# COMMISSION OF ARCHITECTURAL REVIEW

## APPLICATION FOR CERTIFICATE OF APPROPRIATENESS

Address 524 W 21st St  
Historic district Union Hill

November 19, 2019  
Watney Ventures LLC (Ernie Chamberlain) – Owner  
524 N 21<sup>st</sup> St, Richmond, VA 23223

**SKETCH SHOWING THE PROPOSED  
 IMPROVEMENTS ON 524 N 21st STREET  
 IN THE CITY OF RICHMOND, VA.**

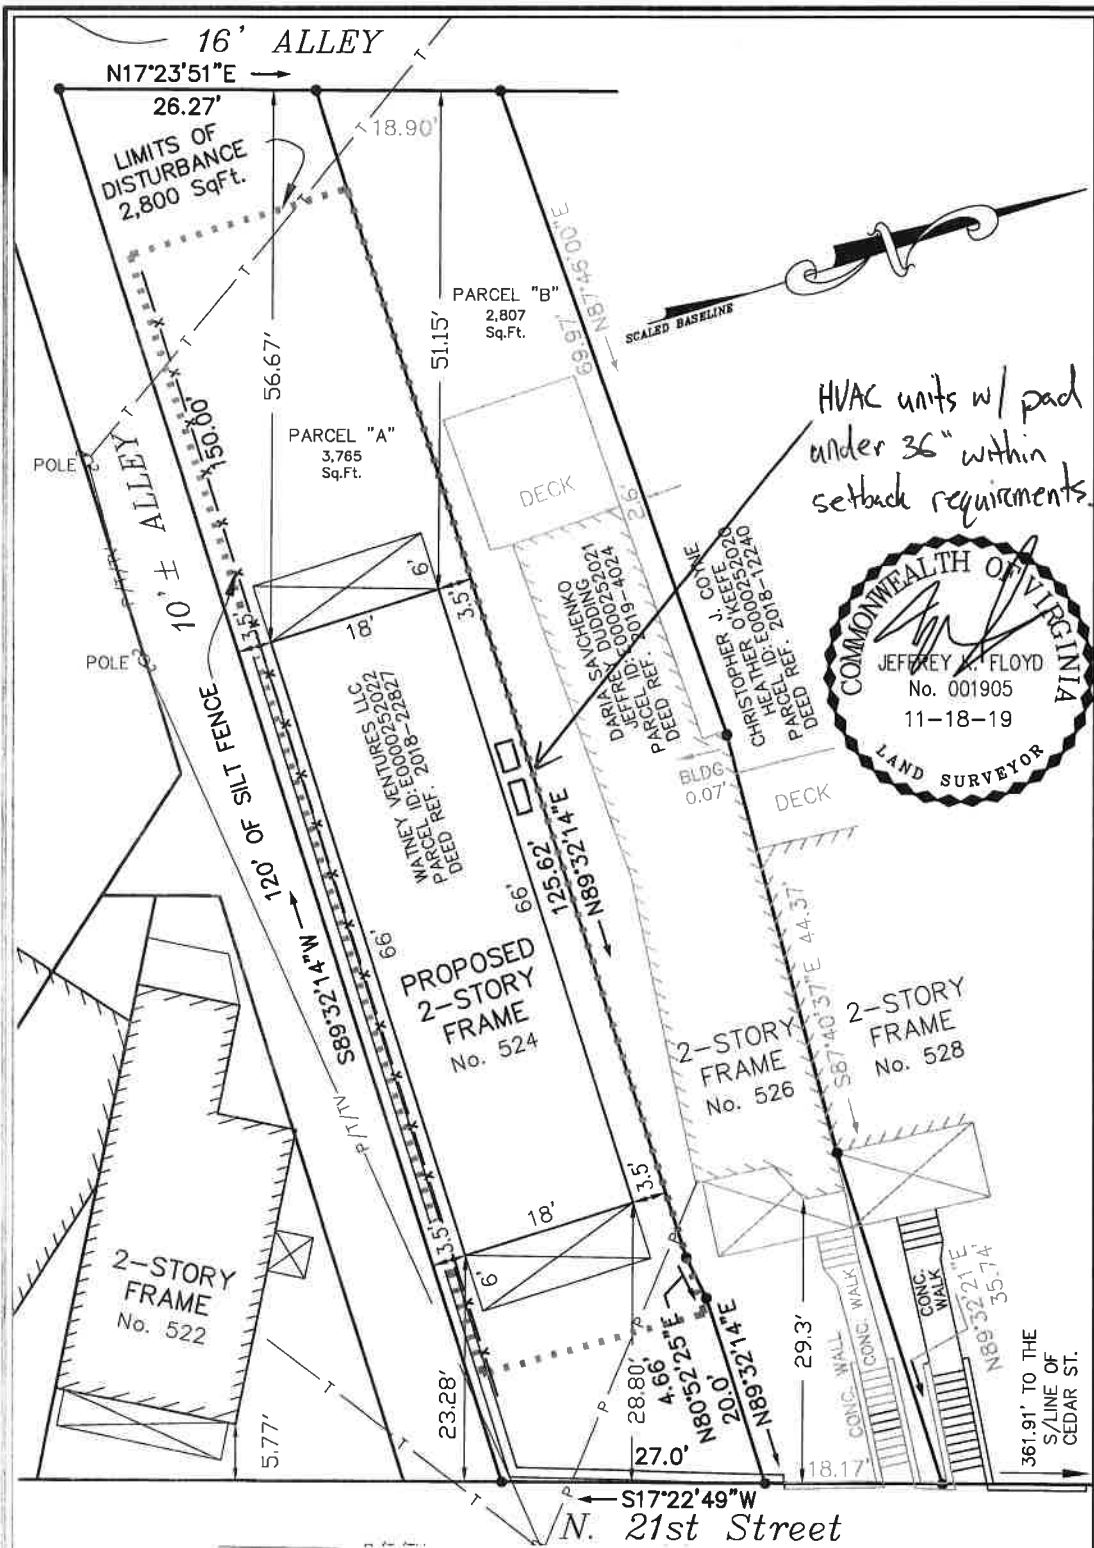
- The As Is built survey now shows the proposed duplex at 524 N 21<sup>st</sup> in line with, or even with, the home at 526 N 21<sup>st</sup> St.
- The second story porch on the front elevation of 524 N 21<sup>st</sup> St has been removed.
- Information, along with photos, have been provided regarding the staircase and access to the front of the duplex.
- Updates have been made to the roofline.
- A photo showing the removal of the retaining wall on the southside of the lot is included. The wall will be replaced by the new foundation of the proposed duplex. No other significant grading/topography changes will be required and plans will follow the recommendations of Koontz Bryand Johnson Williams Group soil test.
- Window schedule is updated.
- Location of HVAC units are included.

HVAC units w/ pad  
under 36" within  
setback requirements.

SKETCH SHOWING THE PROPOSED  
 IMPROVEMENTS ON 524 N 21st STREET  
 IN THE CITY OF RICHMOND, VA.  
 REVISED: 11-18-19  
 DATE: 9-9-19  
 CERTIFIED BY JEFFREY K. FLOYD  
 VIRGINIA CERTIFICATE NO. 001905

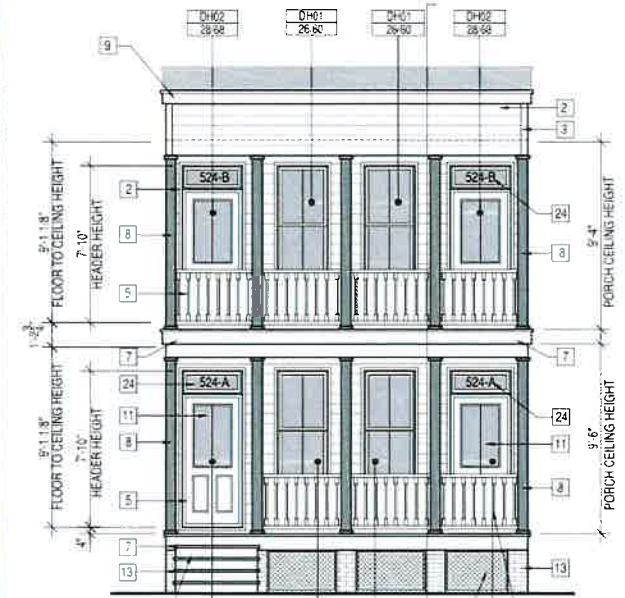
Cinderblock wall facing the street will be parged to match the neighboring homes. A staircase similar to those at 526 and 528 N 21<sup>st</sup> St, seen above next door, will be cut into the existing cinderblock wall fronting the property at 524 N 21<sup>st</sup> St. A brushed concrete path will lead to the door.

The tree in the front of the property will be removed.

Steps leading to 526 and 528 N 21<sup>st</sup> St. Similar steps to be cut into the retaining wall at 524 N St w/ brushed concrete path leading to the door.

Existing retaining wall on the south side of parcel to be removed and replaced by the foundation of the proposed duplex.

524 N 21ST STREET DEVELOPMENT  
 CITY OF RICHMOND, VIRGINIA  
 SCHEDULES AND FIRE WALL INFORMATION

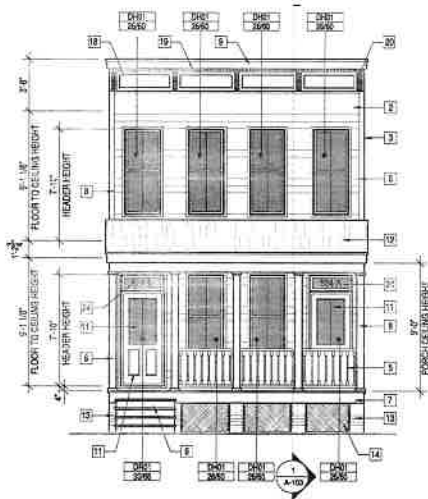
*All windows will be wood - no exceptions.  
 - wood windows throughout the home.*
